#### **Addendum 128 – Regulation No. 129**

#### **Revision 1 – Amendment 1**

Supplement 1 to the 01 series of amendments – Date of entry into force: 22 June 2017

#### **Uniform provisions concerning the approval of Enhanced Child Restraint Systems (ECRS)**

Load application device II

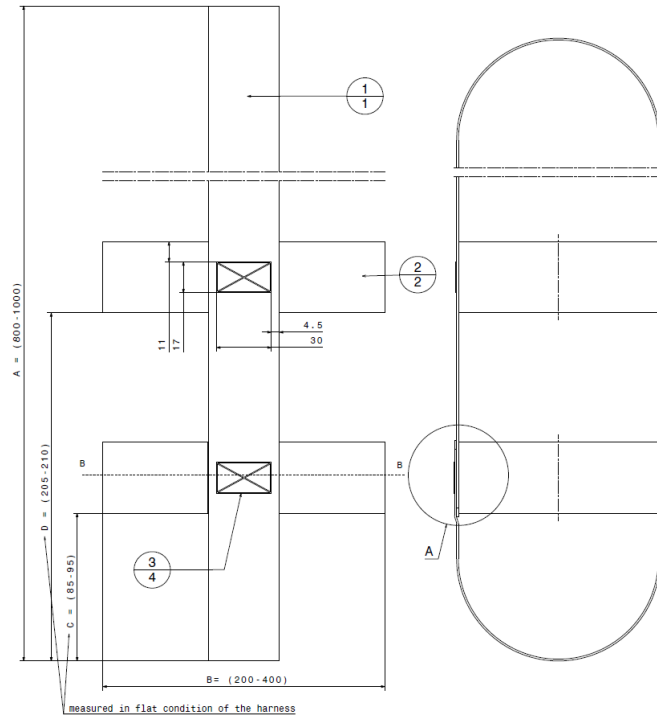
Annex 21, amend to read:

Figure 1

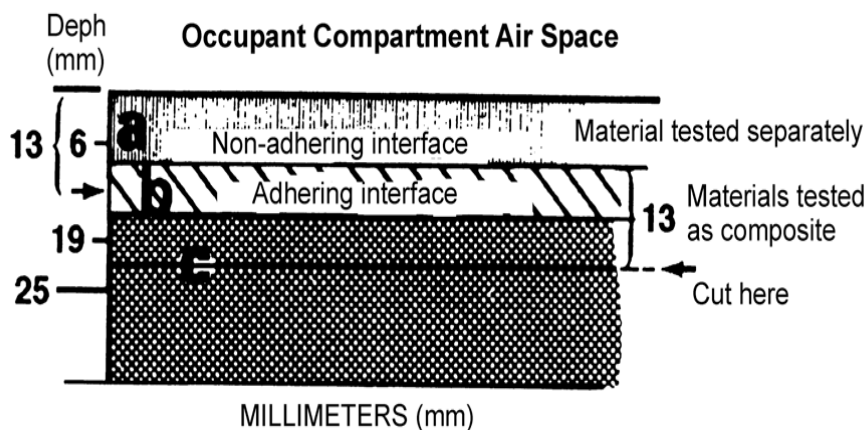
Insert a new Annex 23, to read:

2. Material selection (see Figure 1 below)

2.1. Any portion of a single or composite material which is within 13 mm of the occupant compartment air space shall meet the requirements in Paragraph 6.1.6.

2.1.1. Any material that does not adhere to other material(s) at every point of contact shall meet the requirements of paragraph 6.1.6. when tested separately

2.1.2. Any material that adheres to other materials at every point of contact shall meet the requirements of paragraph 6.1.6. when tested as a composite with the other material(s).

Material A has a non-adhering interface with material B and is tested separately.

Part of material B is within 13 mm of the occupant compartment air space, and materials B and C adhere at every point of contact; therefore, B and C are tested as a composite.

The cut is in material C as shown in Figure 1, to make a specimen 13 mm thick.
